NUCLEAR MANAGEMENT AND RESOURCES COUNCIL

November 30, 1992

**EPRI/TAG Responses to the NRC Staff Comments on the EPRI MOV PPP**  
(November, 1992)

NRC STAFF COMMENTS ON THE EPRI MOV PERFORMANCE PREDICTION PROGRAM  
AND STATUS OF STAFF COMMENTS  
(December 1992)

FIGURE 1

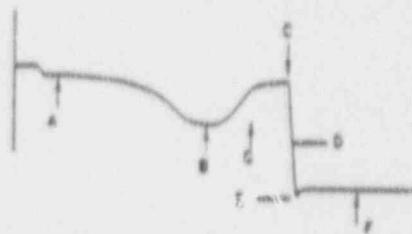
26. In the November 30 letter, EPRI includes Figure 1, "Gate Valve Test Analysis Data Sheet," identifying specific information to be recorded from each MOV test. The staff indicated that some of the abbreviations are not clear. Because these data sheets may be used by valve engineers in setting up similar MOVs, it is important that the data be clearly defined. NUMARC agreed to follow-up on this staff concern.

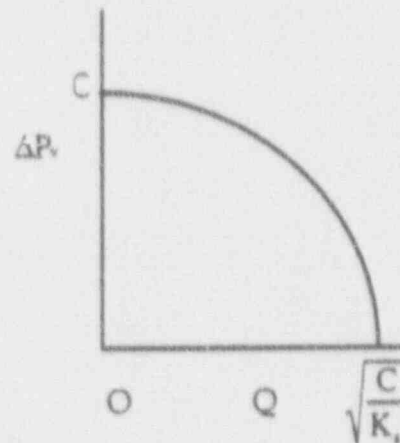
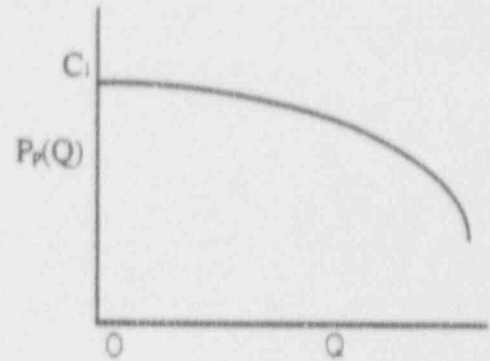
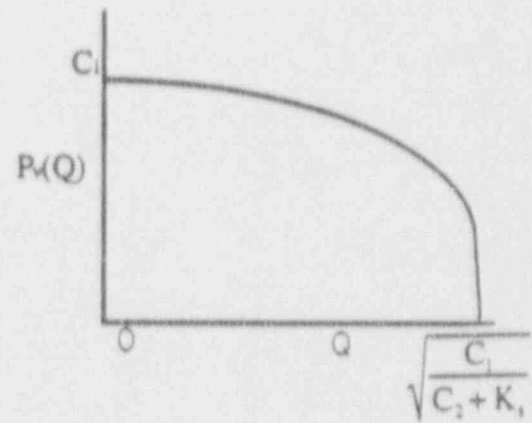
EPRI should provide a detailed description of its method for simulating pump flow to the staff as soon as possible. The staff will review this method of simulating pump flow and will provide EPRI with any concerns regarding this method.

Pump flow characteristic curves for a large number of plant systems were reviewed. In general, the head vs. flow curves were found to be quadratic. Based on the assumption of a quadratic pump curve, the relationship between flow rate and valve DP during a stroke is quadratic and is given by (Ref. Attachment 1):
